SUBJECT: TECHNICAL REVIEW: SALTSTONE WASTE FORM PHYSICAL  
DEGRADATION (DOCKET NO. PROJ0734)

## **Technical Review: Saltstone Waste Form Physical Degradation**

The purpose of this NRC staff Technical Review Report (TRR) is to describe recent research results related to saltstone degradation, evaluate the U.S. Department of Energy (DOE) revised assumptions about saltstone degradation that is in both the DOE Fiscal Year (FY) 2013 and DOE FY 2014 Saltstone Disposal Facility (SDF) Special Analysis Documents<sup>1</sup>, and describe the potential effects of degradation on Savannah River Site (SRS) SDF performance. Release of iodine and technetium (Tc) are discussed in more detail in radionuclide-specific TRRs (ADAMS Accession Nos. ML16342C575 and ML18095A122, respectively).

**Figure 3: Log-Log Plot of the Modeled Hydraulic Conductivity of Saltstone (Reproduced from SRR-CWDA-2016-00004 Rev. 1)**

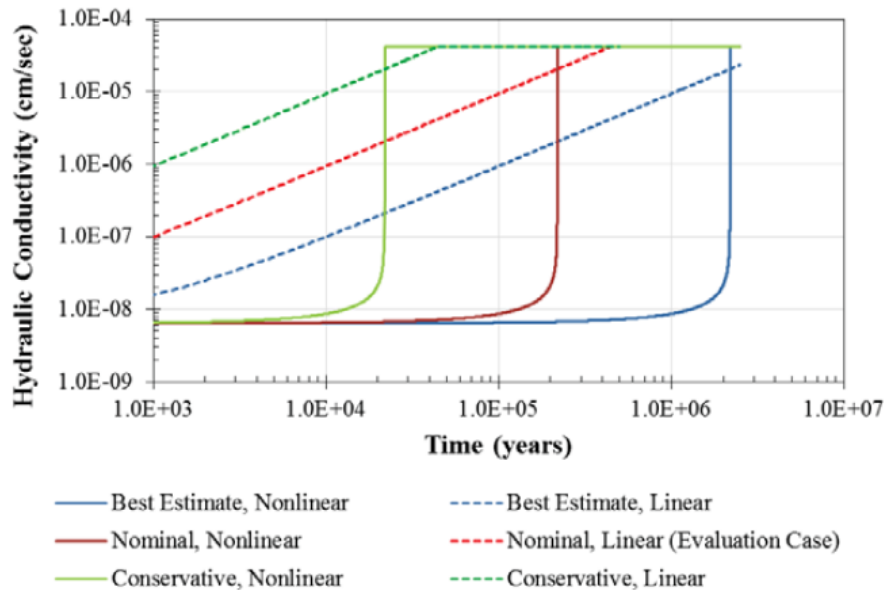
In addition, although the linear degradation rate exceeds the non-linear degradation rate at early times, as shown in Figure 3 below, the hydraulic conductivity for the non-linear model increases

more rapidly at later times. The NRC staff expects that flow through freshly-degraded saltstone would result in greater radionuclide releases than the same amount of flow through previously-degraded saltstone because previously-degraded saltstone would be expected to be more depleted in inventory. Therefore, annual radionuclide releases may be more sensitive to the rate of degradation than the total amount degraded at any time. If that conceptual model is accurate, then a non-linear degradation rate could result in greater annual radionuclide releases and therefore greater dose. In other words, because the release of radionuclides from a linear degradation model is the most gradual release rate possible for a given extent of degradation, it would not be the most conservative model if radionuclide releases are more sensitive to the total annual new degradation rather than to the cumulative amount of saltstone that is degraded. However, if the contaminants of concern are depleted prior to the rapid increase in hydraulic conductivity at later times associated with the non-linear model, then the linear model with the higher initial release would result in a greater dose. Based on the available information, there is not sufficient support for the assumption that the degradation rate will be linear or that a linear degradation rate is conservative.

Figure 4: Semi-Log Plot of the Hydraulic Conductivity Over Time Used in the DOE Response to the NRC RAI Questions on the DOE FY 2014 SDF SA (Reproduced from Figure SP-1.1 in SRR-CWDA-2016-00004, Rev. 1)

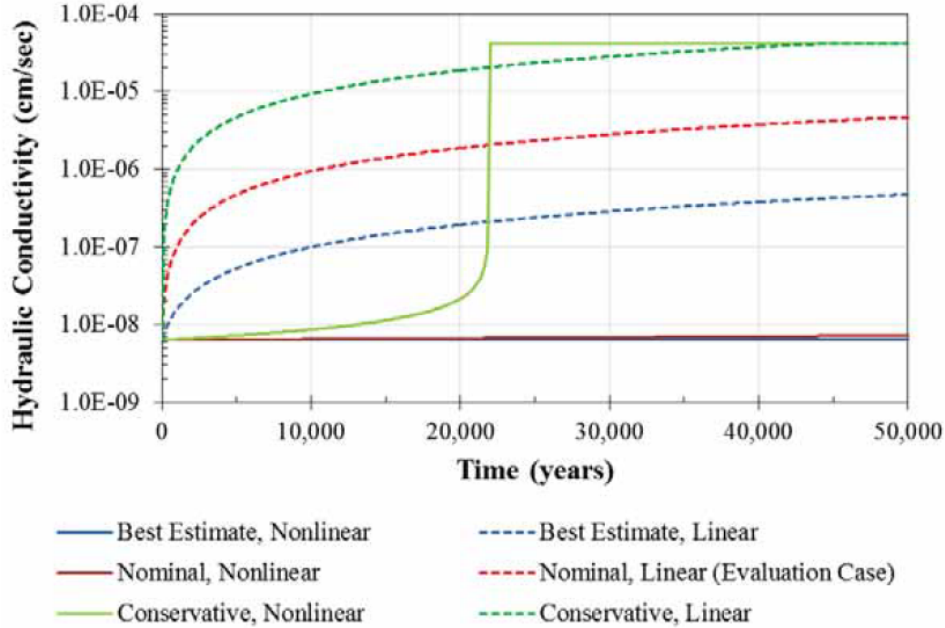
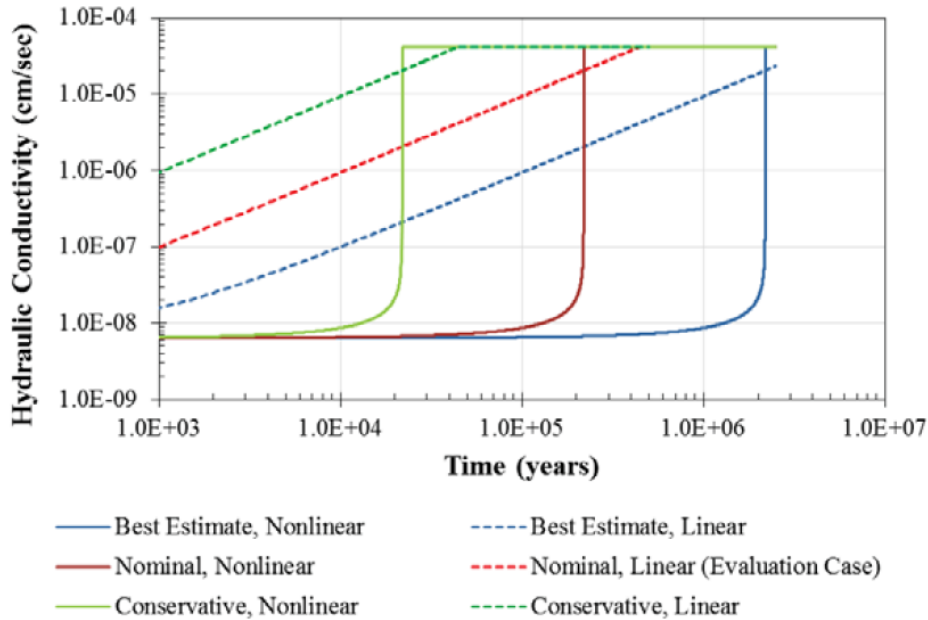
The NRC staff had several questions related to the rate of the DOE assumed degradation due to decalcification (RAI Questions SP-1 and SP-4 in ADAMS Accession No. ML15161A541). In RAI Question SP-1, the NRC staff described the concern that the DOE assumed change in hydraulic conductivity with time did not account for the feedback of increasing hydraulic conductivity as decalcification progresses. As the NRC staff stated:

In response to RAI Question SP-1 (SRR-CWDA-2016-00004, Rev.1), the DOE provided a degradation analysis based on decalcification that compared the linearly increasing hydraulic conductivity (i.e., linear) approach in the DOE FY 2014 Special Analysis to a two-layered system that included a feedback loop (i.e., non-linear) in determining the hydraulic conductivity. As shown in both Figure 4 and Figure 5 below, that analysis showed that including a feedback loop resulted in the fully degraded hydraulic conductivity being reached in about half the time of the constant hydraulic conductivity approach. However, the hydraulic conductivity of the case including feedback remained approximately two orders of magnitude lower than the constant hydraulic conductivity case for more than 10,000 years. That non-intuitive result is due to the inhibition of flow by the non-degraded fraction of saltstone ahead of the decalcification front.

The DOE also considered a more spatially rigorous simulation where the hydraulic conductivity of overlying layers increased relatively quickly with less permeable underlying layers. That conceptual model would result in more lateral flow with water being diverted around the underlying saltstone grout. That process would tend to reduce the peak dose because more water flows around, rather than through the un-degraded saltstone matrix. That process also would tend to move the peak dose earlier in time than in the Evaluation Case because, in the Evaluation Case, Tc-99 is released from overlying cells in the saltstone grout into underlying saltstone grout where it is re-reduced. The bulk of the Tc-99 in the Evaluation Case is not released until the oxidation front migrates through most of the saltstone. The DOE concluded that the simpler conceptual model used in the FY 2014 SA was therefore conservative with respect to the peak dose. The NRC staff agrees with the DOE assessment of the simpler conceptual model of decalcification being conservative compared to the multi-layer model of decalcification with respect to the magnitude of the peak dose. However, the NRC concludes that there is uncertainty in the timing of the peak dose. Recent dynamic leaching research from both the Savannah River Ecology Laboratory (SREL) and the Center for Nuclear Waste Regulatory Analyses (CNWRA) has provided additional understanding of the initial conditions of flow and contaminant transport through saltstone grout. That information, in combination with a more complete degradation analysis, would improve the defensibility of the DOE conceptual model for flow and contaminant transport.

**Figure 8: Projected Release of Tc to the Water Table from a 46-m (150-ft) Diameter Disposal Structure for Varied Percentages of Non-Depleting Oxygen Sources within Saltstone (Reproduced from Figure 5.6.7-12 in SRR-CWDA-2014-00006)**

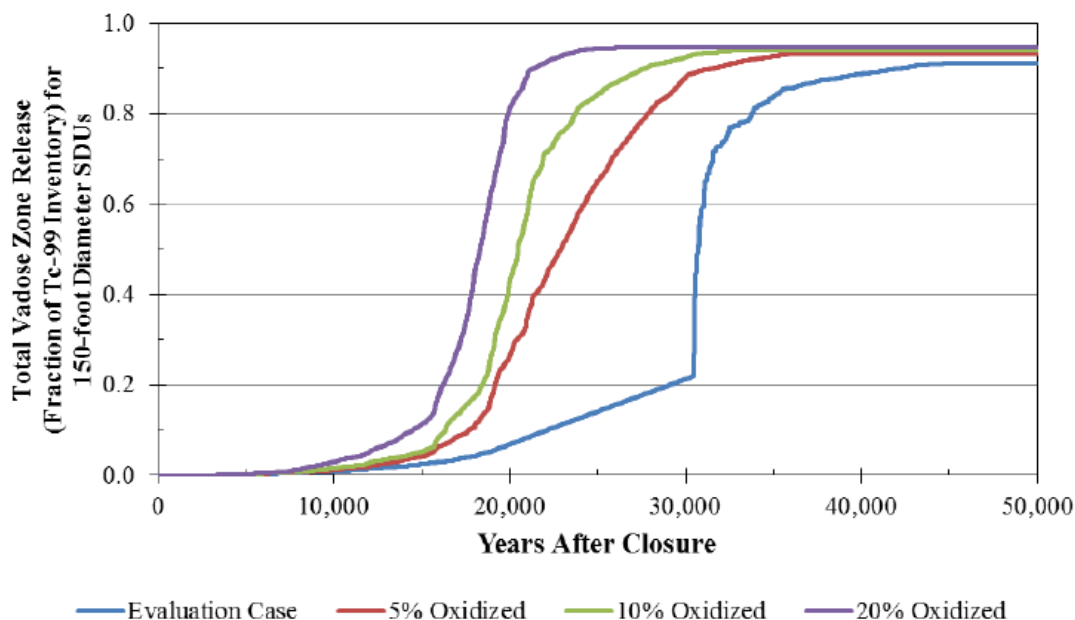
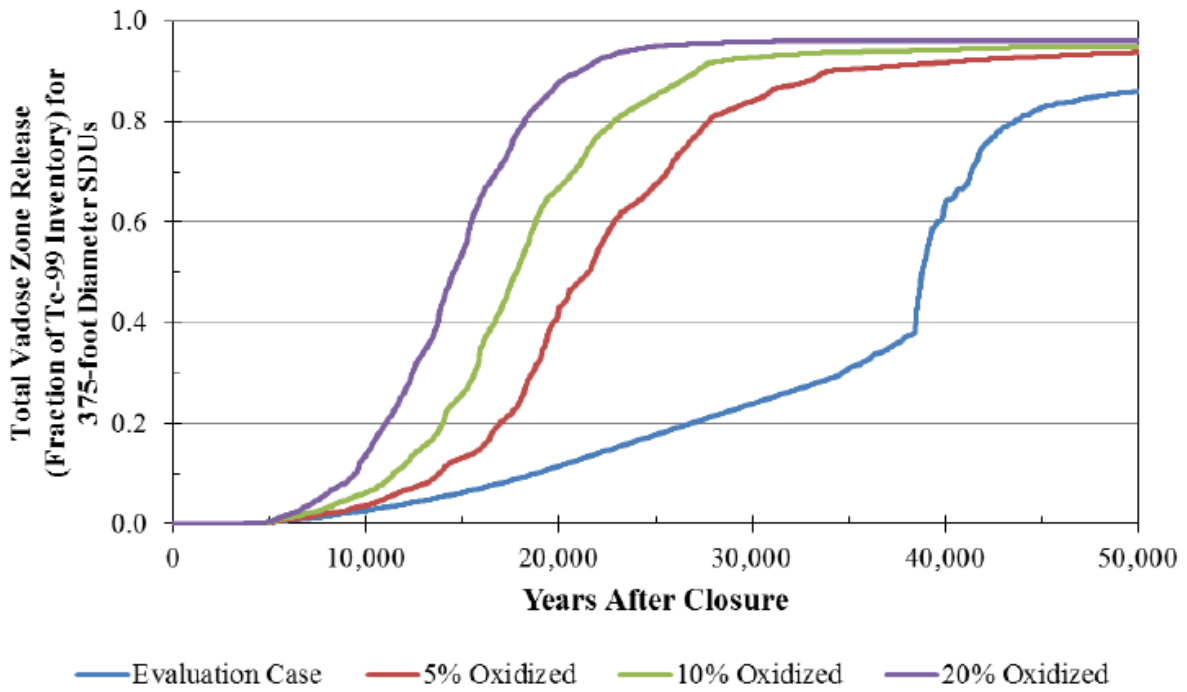
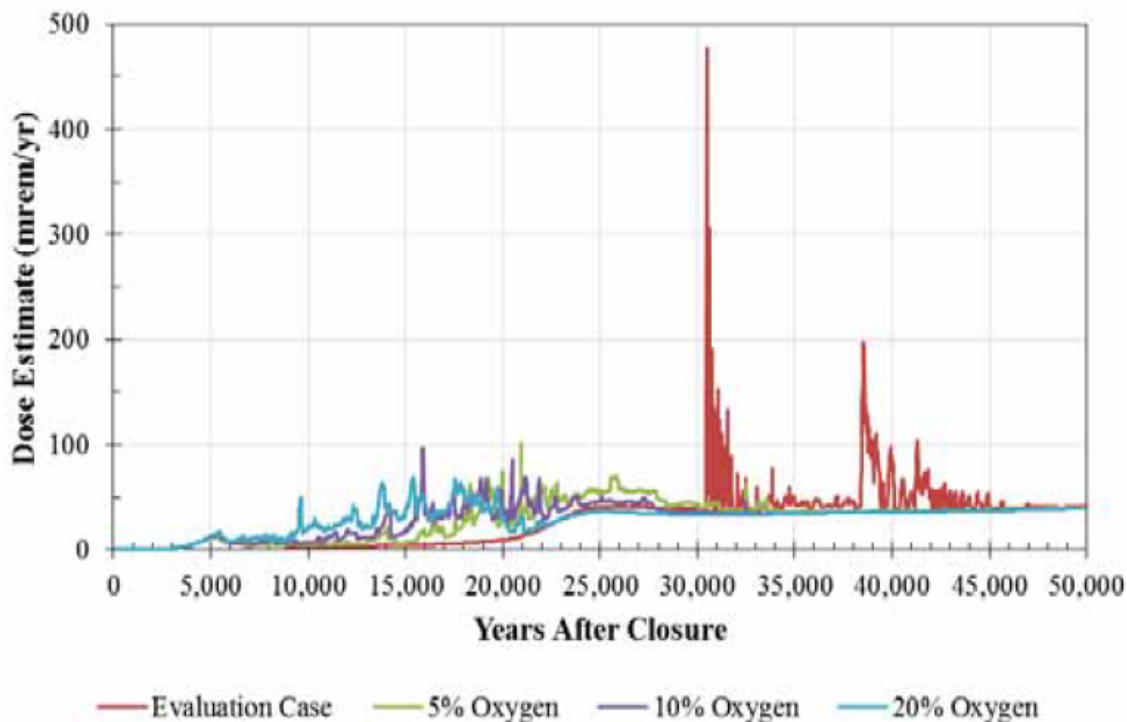
In Section 4.4.1.3 of the DOE FY 2014 SDF SA, the DOE described that it only expected oxygen to enter the disposal structures via infiltrating water (i.e., aqueous-phase transport of oxygen). However, the DOE provided PORFLOW sensitivity analyses in both the FY 2013 and FY 2014 SAs and associated responses to the NRC RAI comments and questions that evaluated the effects of non-depleting oxygen sources on Tc release. Those sensitivity analyses provided insight into the potential significance of gas-phase transport of oxygen through fractured saltstone grout on the release of Tc. Those non-depleting oxygen sources were a non-mechanistic approach to modeling additional oxidation, which could represent oxidation due to gas-phase transport of oxygen in unsaturated fractures. However, the results did not entirely represent the effects of fracturing because the oxidized areas do not coincide

with degraded hydraulic properties, as they would if the sources of oxygen represented fractures.

The modeled regions of non-depleting oxygen sources comprised 5%, 10%, and 20% of the saltstone volume and hasten the modeled consumption of the reducing capacity of the slag and consequently increase the Tc release rate. Both Figure 8 and Figure 9 below show that the non-depleting oxygen-source cases for the 46-m (150-ft) and 114-m (375-ft) diameter disposal structures result in the projected release of Tc occurring earlier in time than the Evaluation Case. However, the modeled peak rate of release (i.e., the maximum slope of the curves in those two figures), which is directly related to the magnitude of the peak dose, is more gradual in the oxygen-source cases than in the Evaluation Case. In response to NRC RAI Question SP-10, the DOE provided a dose approximation to the Member of the Public for each of the cases with varying percentages of non-depleting oxygen sources (SRR-CWDA-2016-00004, Rev.1). Figure 10 shows that the projected peaks from the non-depleting oxygen-source cases occur thousands of years earlier in time than the projected peak dose from the Evaluation Case and that the projected peak dose within 50,000 years of site closure decreased by more than a factor of 4 for the non-depleting oxygen sources sensitivity cases relative to the Evaluation Case. However, within 10,000 years of site closure, assuming that 20% of the saltstone was a non-depleting oxygen source, there was an increase in the projected peak fractional release by approximately a factor of three as compared to the Evaluation Case for the 46-m (150-ft) disposal structures (i.e.,  $3.0 \times 10^{-2}$  versus  $8.8 \times 10^{-3}$ ) and by approximately a factor of five (i.e.,  $1.4 \times 10^{-1}$  versus  $2.6 \times 10^{-2}$ ) for the 114-m (375-ft) disposal structures.

In the NRC Comment SP-1 (ADAMS Accession No. ML14148A153) the NRC staff described that the non-depleting oxygen source sensitivity cases may not adequately represent oxidation in unsaturated fractures, in part, because of modeled re-reduction of Tc throughout the wasteform. The random placement of the oxygen sources also might not be representative of flow and transport of redox-sensitive radionuclides through a network of fractures in which Tc might encounter fast flow pathways and might not encounter reduced areas of saltstone.

**Figure 11: Assumed Saturated and Unsaturated Hydraulic Conductivity of Saltstone in the Evaluation Case from the DOE FY 2014 SA (Prepared from the DOE PORFLOW Data)**

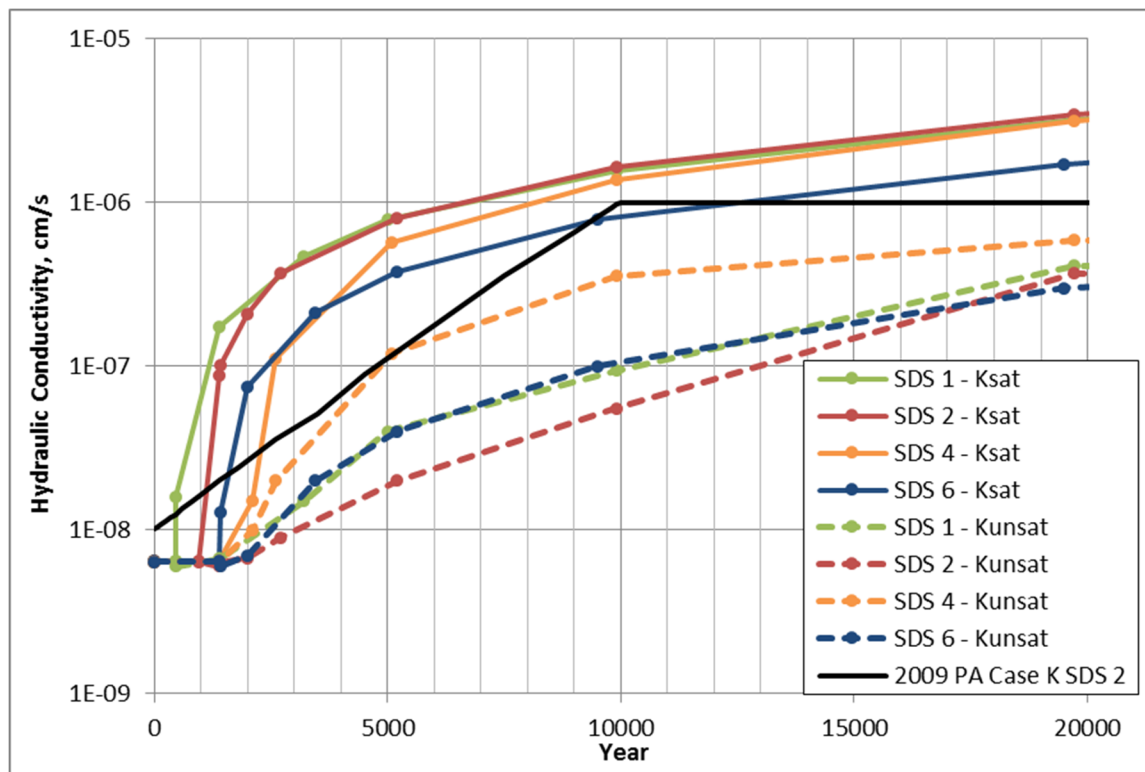
In both the DOE FY 2013 and FY 2014 SDF SAs, the DOE again used MCCs for saltstone. However, the MCCs in these documents, versus the DOE 2009 SDF PA, varied in time to simulate degradation (SRR-CWDA-2013-00062, SRR-CWDA-2014-00006). The assumed saturated and unsaturated hydraulic conductivities in the Evaluation Case in the FY 2014 SA are shown in Figure 11<sup>6</sup>.

The unsaturated hydraulic conductivity values are derived in the PORFLOW near-field model as a function of the assumed saturated hydraulic conductivity, MCCs, and saltstone saturation, which all vary in time. The saturated hydraulic conductivity values were direct inputs into the PORFLOW near-field model and were based on the DOE assumed rate of degradation, as discussed previously in this document. The MCCs, which are also direct inputs into the PORFLOW model, were assumed to vary in time to simulate degradation, as discussed previously. Then, based on those model inputs and the saturation calculated in the PORFLOW model, PORFLOW selects the corresponding unsaturated hydraulic conductivity from the assumed MCC tables of saturation versus unsaturated hydraulic conductivity for each time interval. The PORFLOW calculated saturation of saltstone in each of the disposal structures ranged from 99.86% to 100% within 10,000 years. For the unsaturated hydraulic conductivity values shown in Figure 11, the NRC staff cross-referenced the saltstone saturations calculated within PORFLOW with the corresponding relative permeabilities from the assumed MCC look-up tables for several time intervals.

Based on the assumed saturated hydraulic conductivity values, MCCs, degree of saturation, and the corresponding relative permeabilities shown in Figure 11, the DOE projected that the hydraulic conductivity of unsaturated saltstone would decrease relative to the saturated hydraulic conductivity by a factor of up to 30 for SDS 2 (and the other 46-m [150-ft] disposal structures) within 10,000 years. For SDS 6 (and the other 114-m [375-ft] disposal structures), the relative permeability was projected to decrease by up to a factor of approximately 10 within 10,000 years. A decrease in permeability of a factor of 30 with a decrease in saturation of 0.14% is not consistent with other cementitious materials, as shown in Figure 2.7-4 of the 2012 NRC SDF TER (ADAMS Accession No. ML121170309).

**Figure 12: Assumed Saturated Hydraulic Conductivity of Saltstone Grout in 46-m (150-ft) Diameter Disposal Structures (Prepared From the DOE PORFLOW Data)**

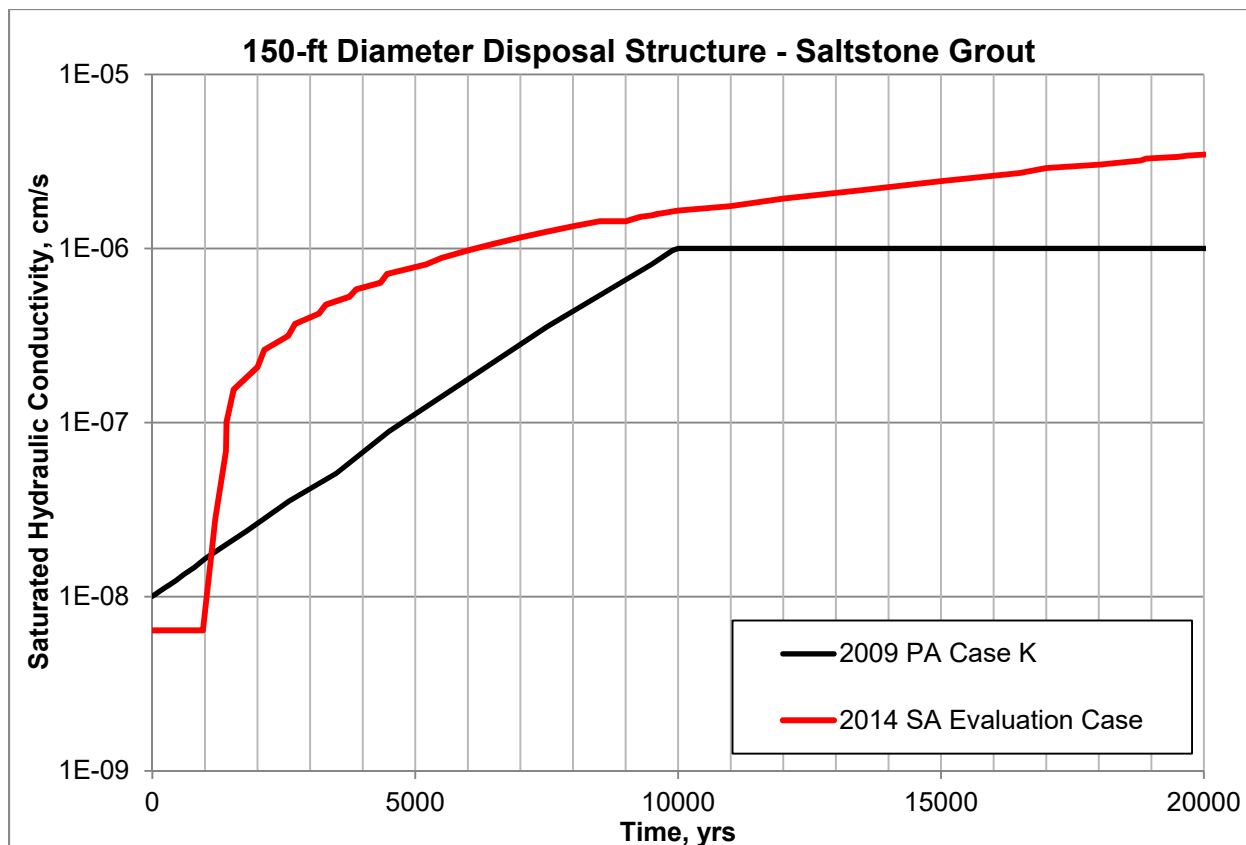
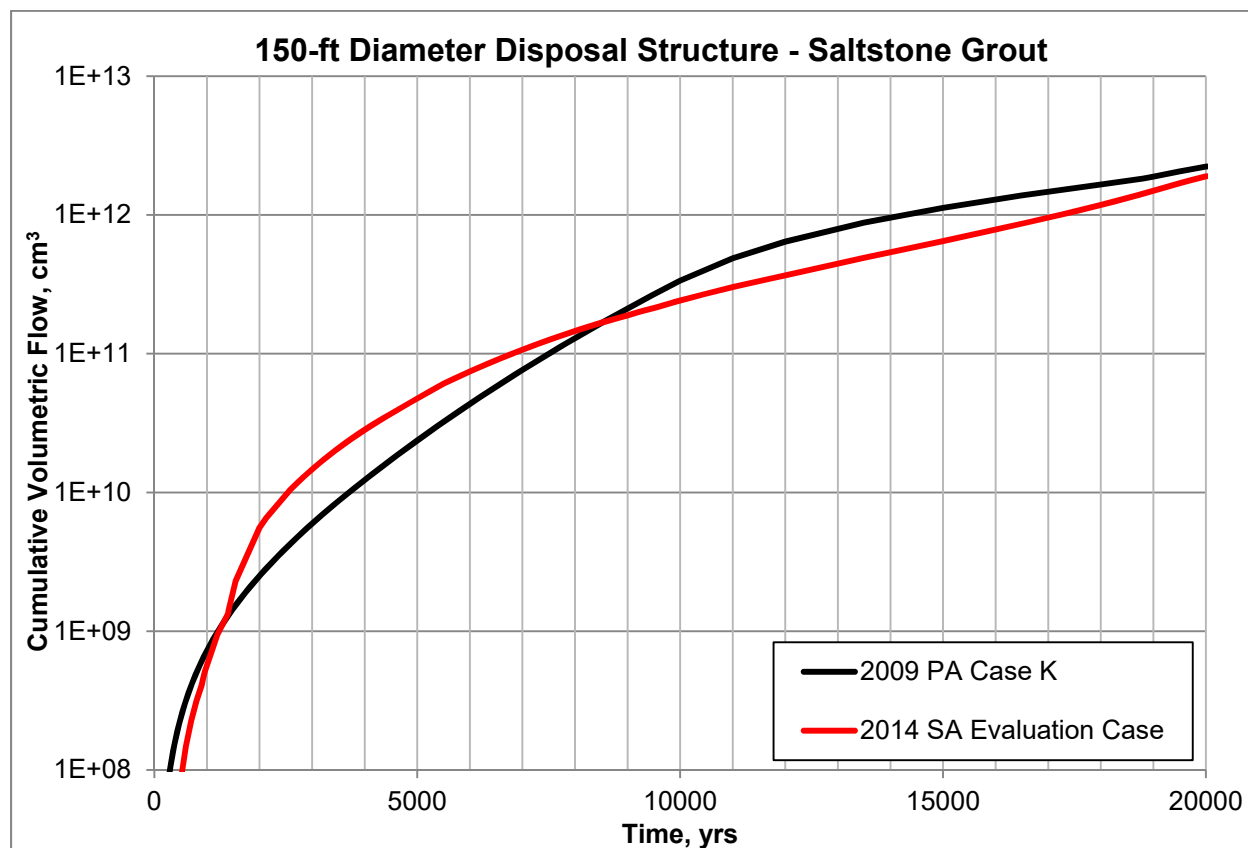
The assumed saturated hydraulic conductivity values in the Evaluation Case in the FY 2014 SDF SA typically exceeded those of Case K for the 46-m (150-ft) diameter disposal structures by up to approximately a factor of 10, as shown in Figure 12. However, Case K assumed that the relative permeability of saltstone was 1.0 at all saturations, whereas the Evaluation Case included MCCs that decrease the hydraulic conductivity according to the degree of saturation. Intermediate PORFLOW model results from Case K and the Evaluation Case in Figure 13 show that those two assumptions nearly balance each other with respect to the cumulative volumetric flow and the rate of increase in flow through saltstone. However, the NRC staff remains concerned that there is significant uncertainty associated with the degradation of saltstone and, therefore, the saturated hydraulic conductivity, as well with the assumed MCCs and the saturation of saltstone.
